**Re: Scoping and Environmental Review Process for the Rosemont Copper Project**

**Re: Scoping and Cooperator Status for the Rosemont Copper Project EIS**

**Re: Rosemont Mine Plan of Operations July 11, 2007 - Review for Completeness**

**RE:** PDEQ Comments on Augusta Resource Corporation's Rosemont Project Mine Plan of Operations

Figure 1) Location of Other Deposits at RP same as Figure 6-2 in 2007 Mineral Resource Update.

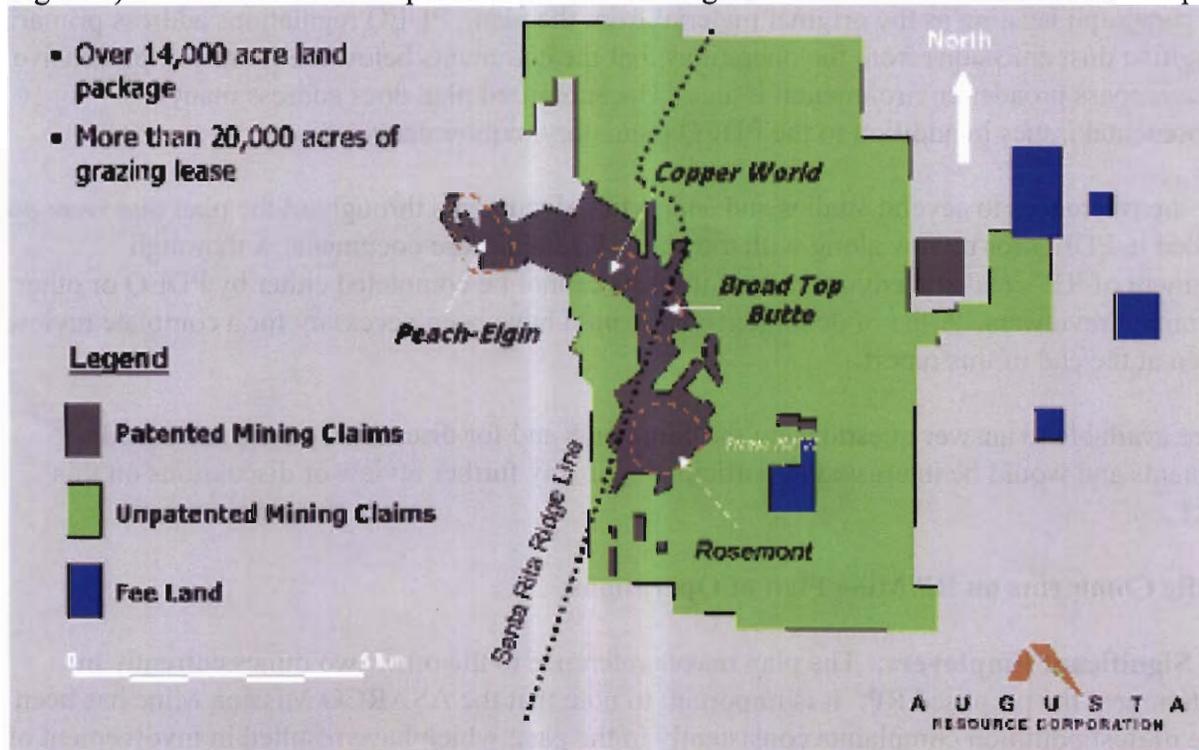
**2.1.1 Open Pit Plans:** The RP open pit configuration is stated to ultimately be "about 6,500 ft across north to south, 6,000 ft across east to west, and will be about 1,800 to 2,900 ft deep." It is understood exact pit configuration cannot be determined now due to the fluctuation in metal prices and precise information on the distribution of mineral reserves. However, PDEQ would like to see some limitations on pit size included in the document so that a guarantee is given on the allowable extent of the pit.

Review of the 2007 Mineral Resource Update for the Rosemont Project, dated April 26, 2007, revealed the presence of a total of 4 deposits on the Rosemont Property. They included the Rosemont Deposit, which ARC has planned to extract, the Broadtop Butte Deposit to the north of Rosemont, the Copper World Mine to the north and west, and the Peach-Elgin Deposit to the north and west. All three of the other deposits lie partially or completely over the ridgeline of the Santa Rita Mountains (see Figure 1 below.) Development of these potential resources in the future would lead to visual and physical impacts not addressed in the plan. In order to consider this version of the plan complete, PDEQ would need some statement incorporated that these deposits specifically will *NOT* be developed in the future, regardless of economic incentive. Incorporation of such intentions in the closure planning of the mine will be necessary to prevent sale of the other deposits to mining interests in the future. The recent complaint filed by ASARCO contesting ARC's ownership of the mine testifies to other firms' interest in the Santa Rita Range (<http://biz.yahoo.com/iw/070824/0294999.html>).
